Product hierarchy no. *				Part no.	SBU	Type / Description	Customer part no.
SBU	PG	PUG	Type				
80	084	002	0000006146	See list below	EMC	FMLB-09

3 Detailed description of change

Product Change Notification					PCN FMLB-09 case 73 redesign		
owner	creation date	release date	released by	change order no	rev	page	D10-047-007
segatro	03.07.2020	10.07.2020	blumhe	2020132	A	1 of 2

Old product appearance	New product appearance

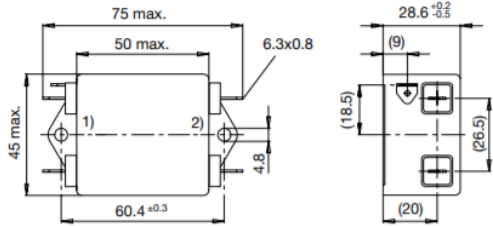
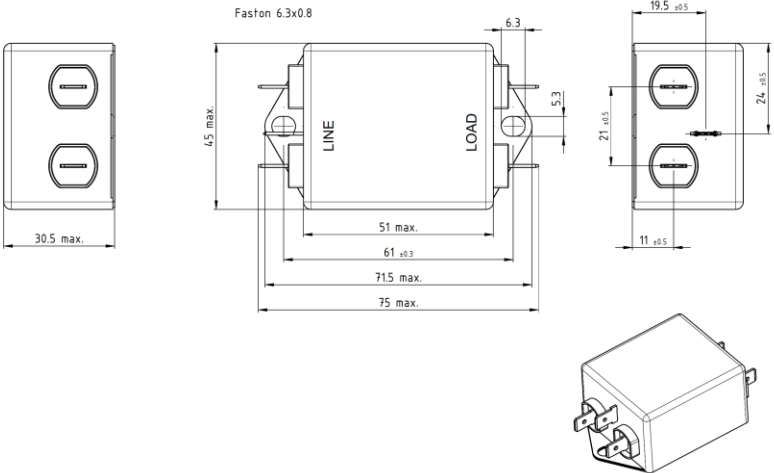
- Nickel plated steel case instead of aluminium case
- Different shape and position of external quick connect terminals
- Different position of earth terminal
- Different fixing center distance

- Change of product appearance due to new nickel-plated steel case instead of aluminium case
- New case is provided with a bottom cover
- Moved position and different shape of plastic part for external quick connector terminals
- Moved position of earth terminal
- New elongated mounting hole with different distance 60.4 ±0.3 to 61 ±0.3 fits old mounting dimensions
